**City of Portland, Maine – Building or Use Permit Application** 389 Congress Street, 04101, Tel: (207) 874-8703, FAX: 874-8716

# BUILDING PERMIT REPORT

DATE: 4 June 97 ADDRESS: 14 Pleasant Ave.  
REASON FOR PERMIT: To enlarge and enclose existing deck  
BUILDING OWNER: Roger S. Zimmerman  
CONTRACTOR: owner  
PERMIT APPLICANT: [Signature] APPROVAL: \*12, \*7, \*9, \*26 ~~DELETED~~

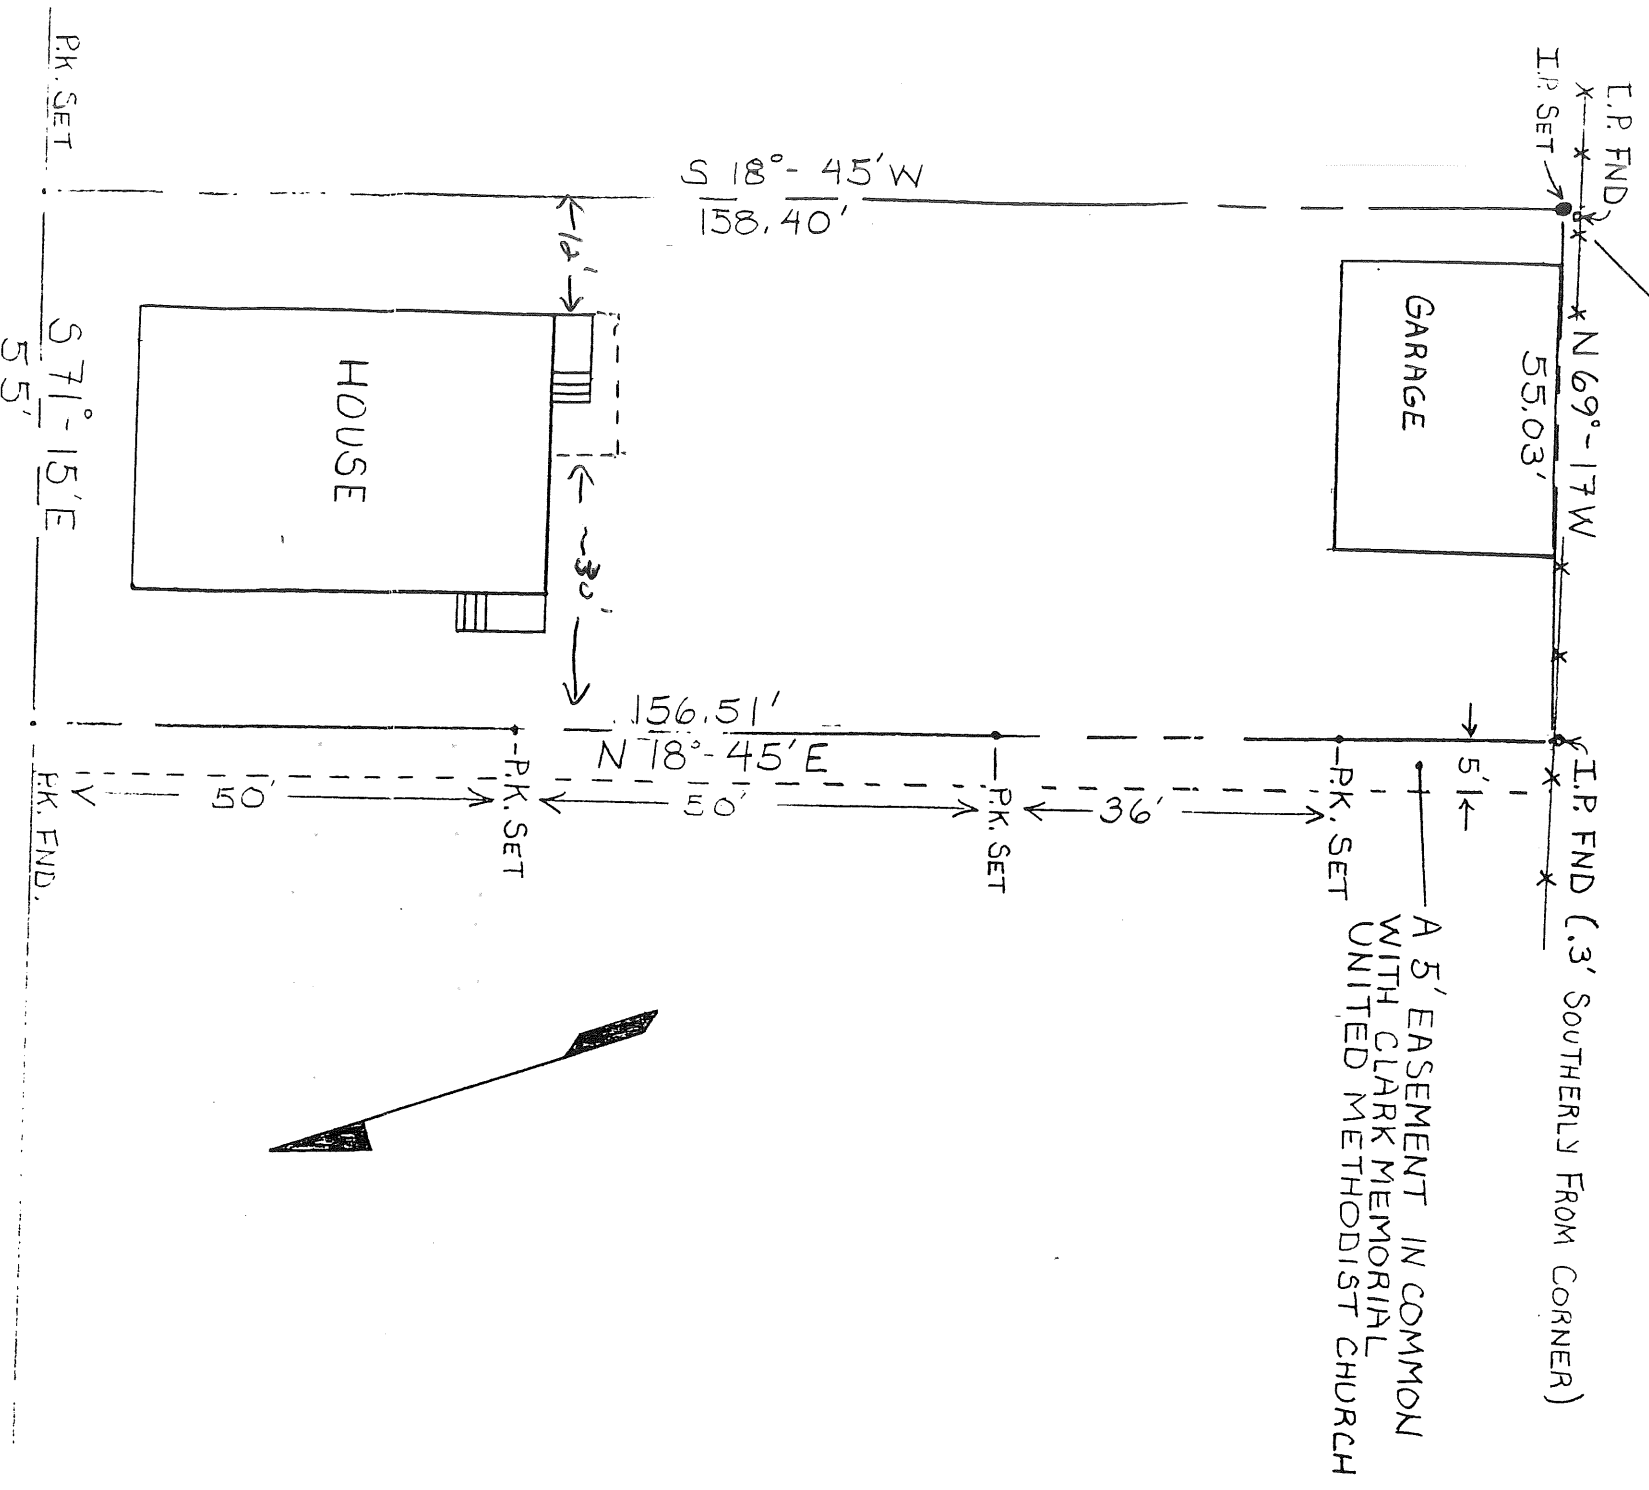
- 25. All electrical and plumbing permits must be obtained by a Master Licensed holders of their trade.
- 26. Your plan doesn't show the foundation system for the proposed addition, please submit this information before work begins. A minimum of 8" solid tubes on a footing 4' below grade with anchor between footing and pier would be required.

Regarding Building Permit for the proposed project, enlarge and enclose porch on back of house, 14 Pleasant Ave., Portland, the permit was issued with conditions and a request for information about the foundation system. The plan is for the porch to be supported on 6 x 6" pressure treated timbers, which are to be placed on hardtop (the hardtop is part of a parking lot that abuts the side and rear of the house, and is shown on the visuals already submitted to the dept. with the application for a building permit). Hence, no cement will be poured (regarding condition #2). The porch will be enclosed, and hence guardrails will not be needed (re: condition #7), i.e. there will be walls. Re #9, the pre-existing stairs will be re-used, and these satisfy the requirements of condition #9.
